O-9 Environmental Center of San Diego

Comment Letter O-9

The Environmental Center of San Diego (ECO SD) would like to offer the following comments on the Draft Environmental Impact Report (DEIR) for the Newland Sierra development project in North County.

June 2018 RTC-801 Newland Sierra Final EIR

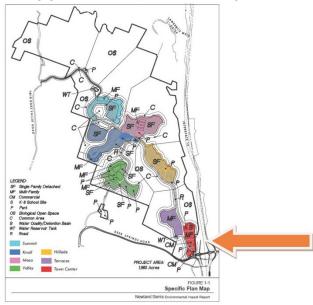
Another under-analyzed edge effect issue is the one of residents' behavior toward habitat areas and open space in the name of 'fire management'. In the photo example below from Bernardo Mountain' can be seen evidence of how some landowners deal with the fire risk to their homes when located in open space areas. This denuded area alternately fills with weeds, increasing fire hazards or is scraped of all vegetation, exacerbating erosion and destroying any habitat value. Unfortunately, this the over-reaction of creating 'defensible' space must be assumed. Also, why is the plan to include 250 feet of FMZ instead of the usual 100 feet?
